SAN ANSELMO FLOOD RISK REDUCTION PROJECT

Second Addendum to the 2018 San Anselmo Flood Risk
Reduction Project Final Environmental Impact Report
(SCH # 2017042041)

Prepared for
Marin County Flood Control and Water
Conservation District

November 2023

Figure 2
Updated Downtown San Anselmo Site Plan (Modified Project)

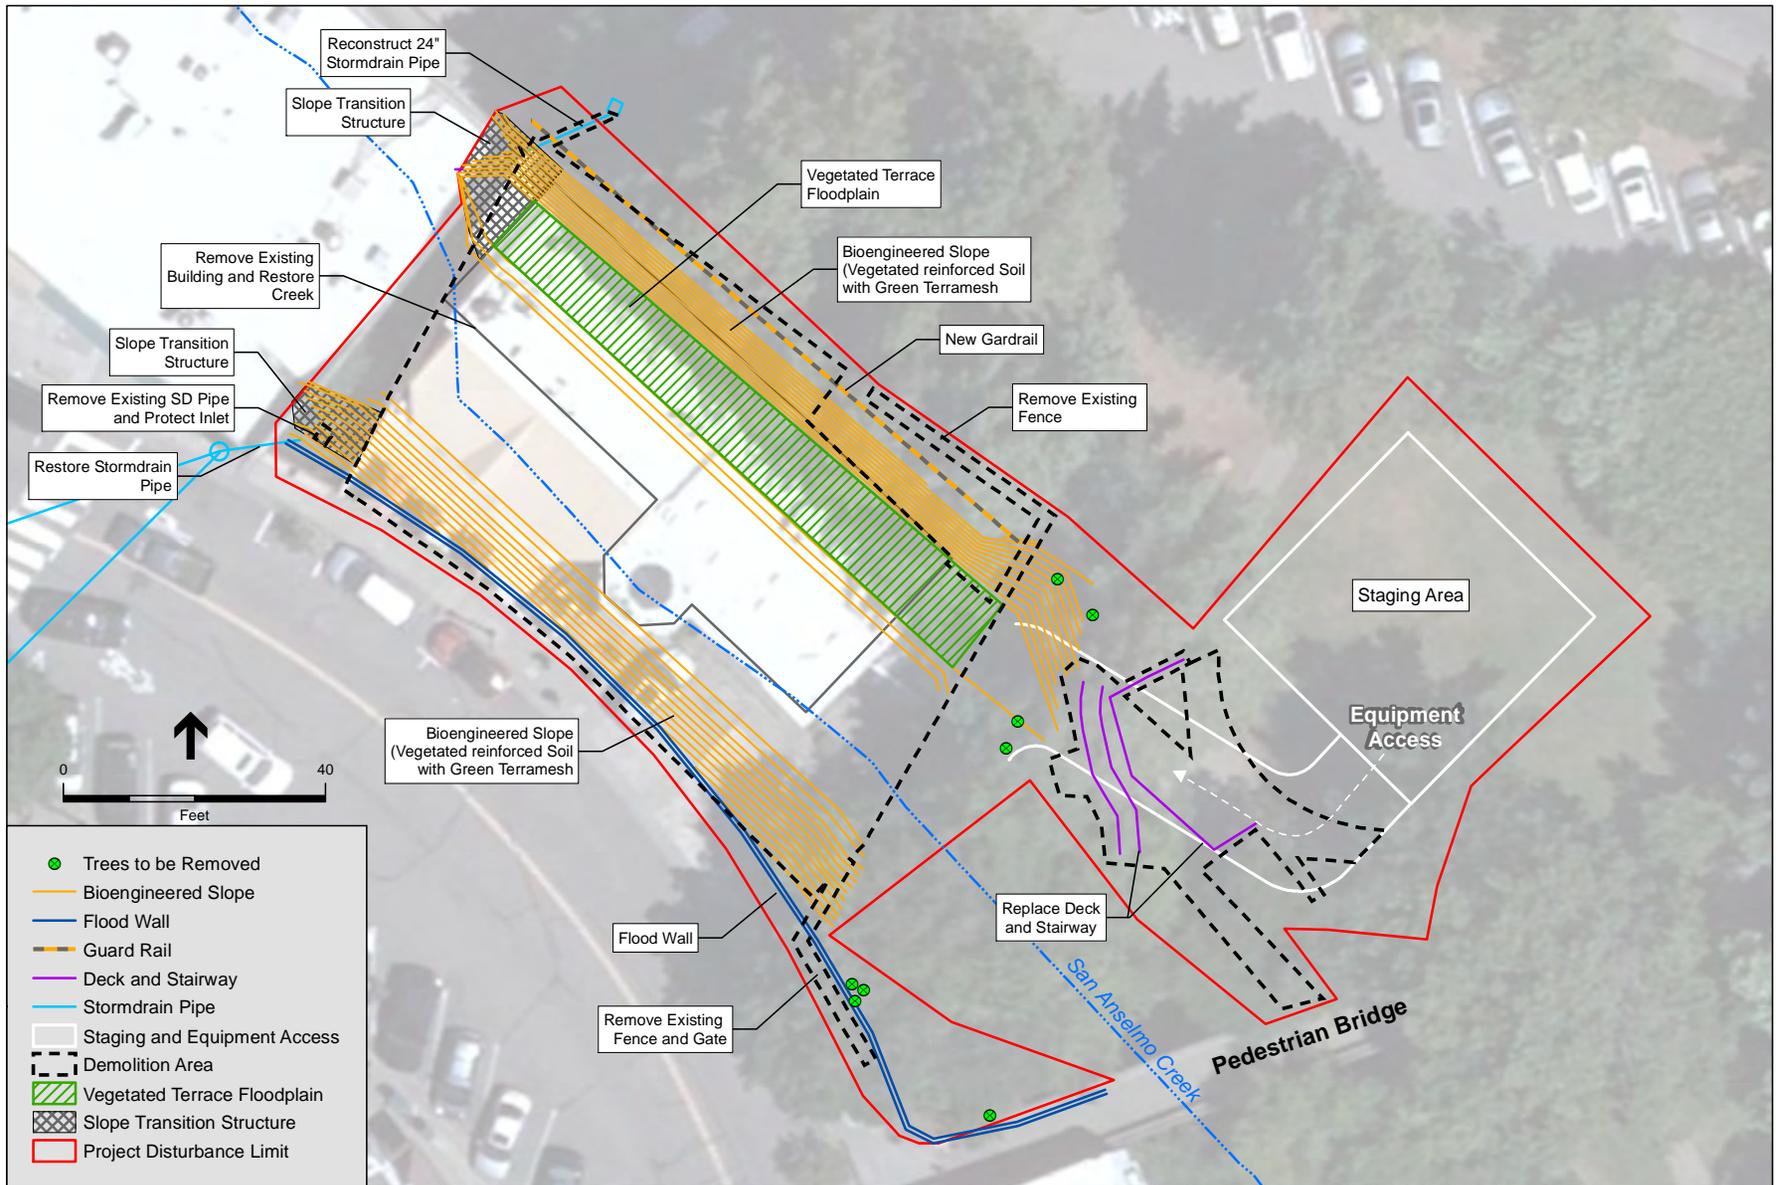
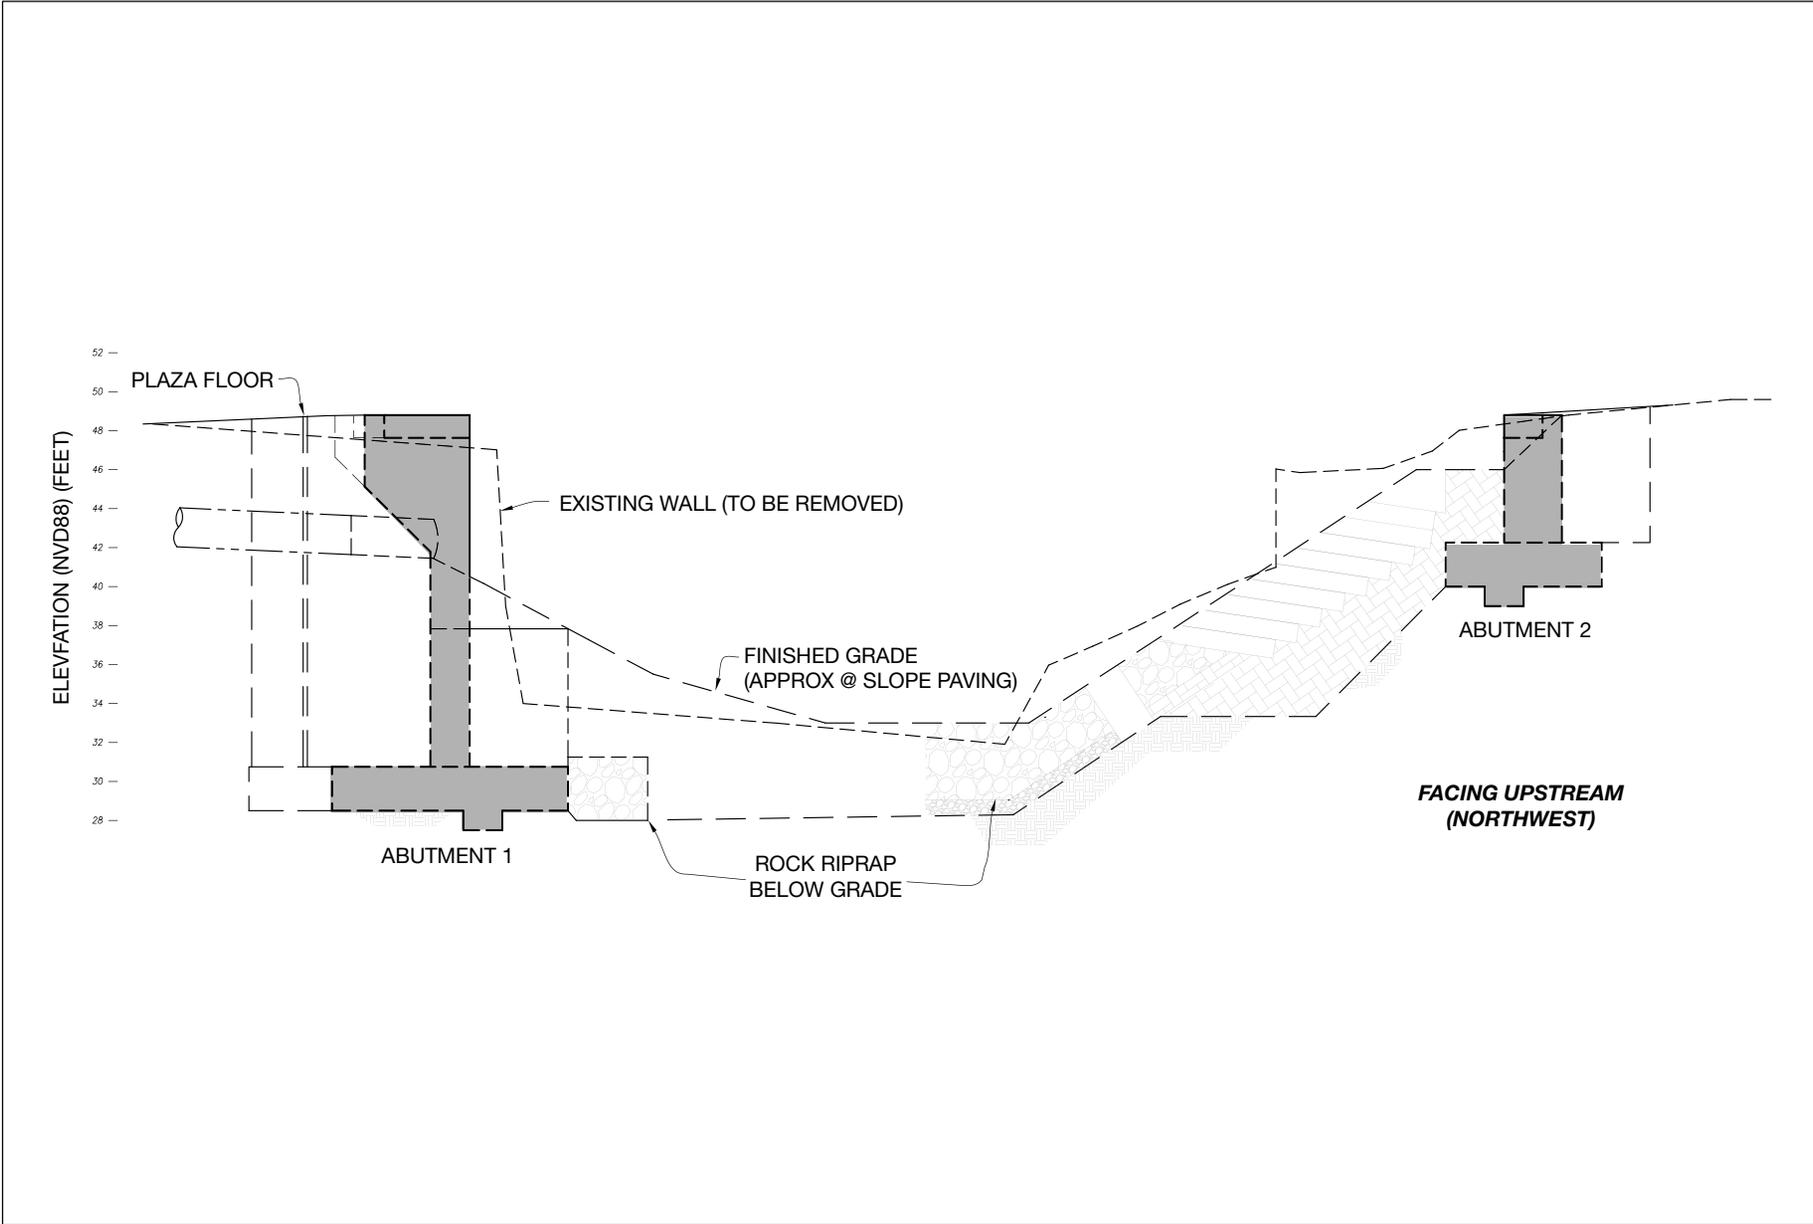
Since approval of the project, the District also proceeded with further design of the downtown San Anselmo site components of the project, which is located at 634-636 San Anselmo Avenue in San Anselmo along San Anselmo Creek. Most project components are the same, as shown in **Table 1**. This chapter describes modified project components at the downtown San Anselmo site. **Figure 2** illustrates the modified project components at the downtown San Anselmo site. **Figure 3** is the FEIR approved project site plan, provided for comparison purposes.

Downtown San Anselmo Components Evaluated in the FEIR (Approved Project)	Proposed Facilities (Modified Project)	Proposed Quantities
Removal of Building at 634-636 San Anselmo Avenue	Completed	N/A
Removal of Concrete Foundation of 634-636 San Anselmo Avenue	Same	7,000 square foot concrete deck 100 linear feet
Replace existing concrete foundation wall under Building Bridge 2 with Bioengineered Slope and Slope Protection along San Anselmo Avenue Bank	Replace existing concrete foundation wall under Building Bridge 2 with retaining wall along San Anselmo Avenue	75 foot long retaining wall 11-foot-wide concrete footing 57 cubic yards of riprap
Flood Wall along San Anselmo Avenue	Same	N/A – outside of creek top of bank
Bioengineered Slope and Slope Protection along Creek Park Bank	Same, with riprap at toe of bank	170 linear feet 2,095 square feet (0.05 acre) of vegetated soil lifts 179 cubic yards of riprap

Figure 5
Project Variant: Proposed Baffle, Looking Upstream

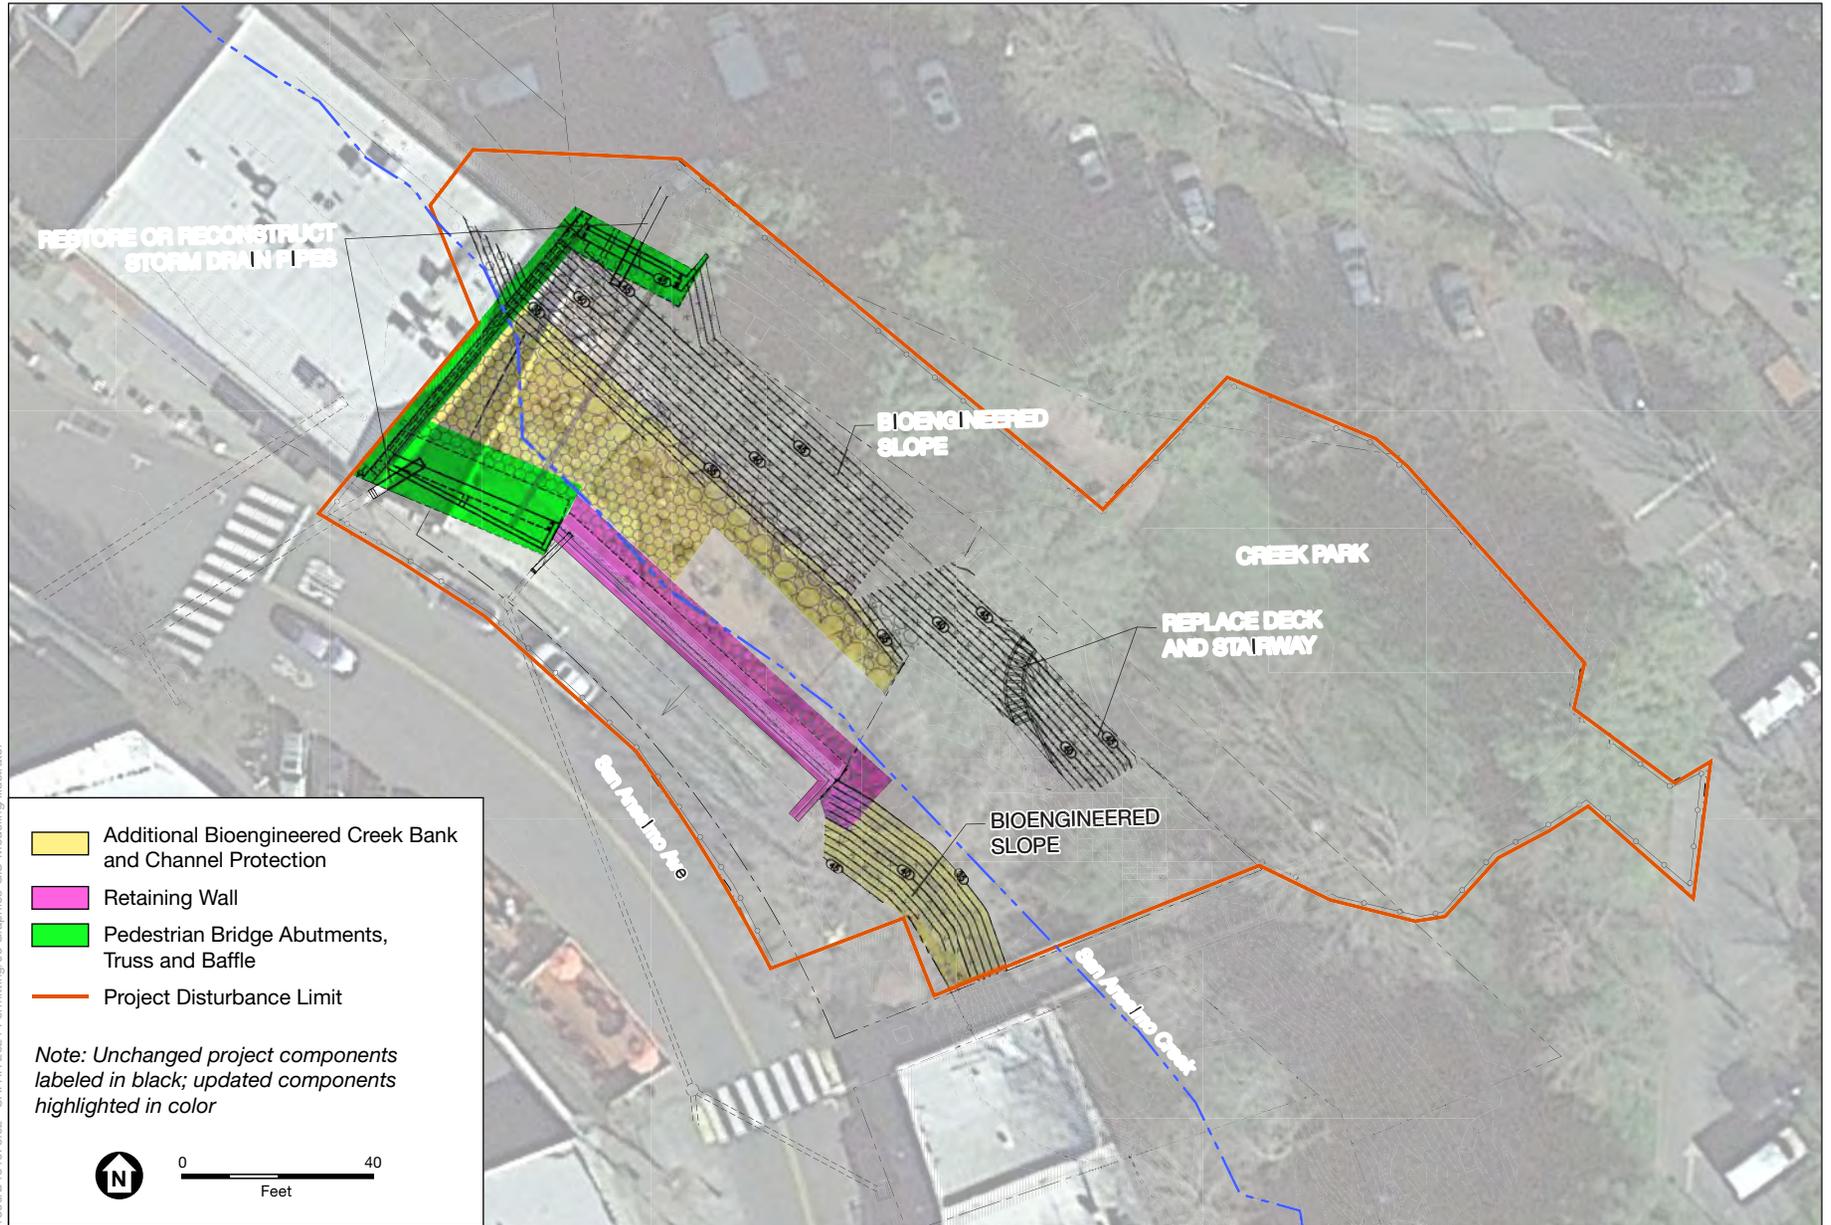
As a variant of the modified project at downtown San Anselmo, in addition to the other components above, the District would incorporate a *baffle*² into pedestrian bridge abutments and place channel bed scour protection downstream of the baffle in San Anselmo Creek. The baffle would be designed to avoid changing water surface elevation during the 25-year and 100-year

The baffle, which would remain in place until its removal would not change the downstream 25-year and 100-year floodplains, would consist of precast concrete panels added to the northwestern (upstream) side of the pedestrian bridge abutments. The baffle would be secured by an approximately 65-foot-long truss extending across the creek and additional concrete foundations set in the bank along Creek Park. The truss would extend vertically approximately four feet above the top of the baffle. An opening approximately 35 feet wide would separate the concrete panels of the baffle and allow the low flow creek to pass through the opening. The top of the opening (the base of the truss) would be at elevation 47.7 feet. A conceptual graphic of the baffle is shown in **Figure 5**. **Figure 6** shows the site plan with baffle and associated channel bed scour protection. Approximately 160 cubic yards of additional channel bed scour protection would be needed to replace the existing bed protection provided by the foundation of 634-636 San Anselmo Avenue.
